Access Compliance Report

Public Rights-of-Way (Curb Ramps)

Intersection ID: N/A	Main Street: DIXIE_RIVER_RD	Cross Street: N/A	Location: NE
ADA ID: D6E43965C855	Ramp Type: BlendTrans1	Initial Pass/Fail: Pass	Overall Compliance: No
Severity Score: 0			
Codes/Mitigation Info/Possible Solution		Field Measurements/Component Compliance

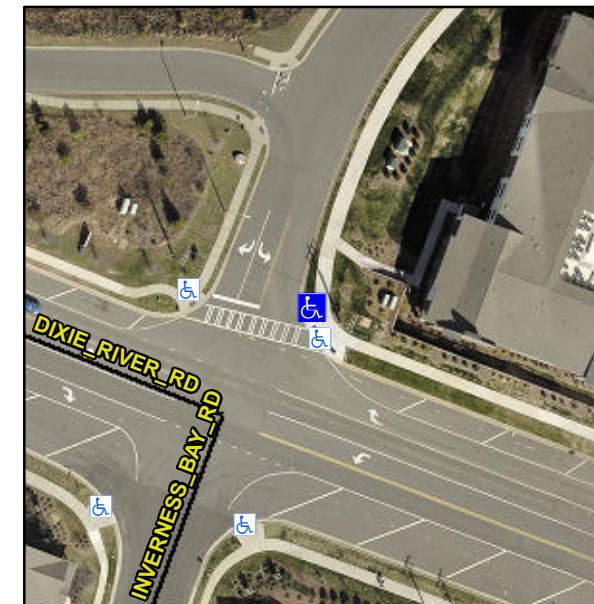
Remove & Replace Detectable Warning System.

R305.2
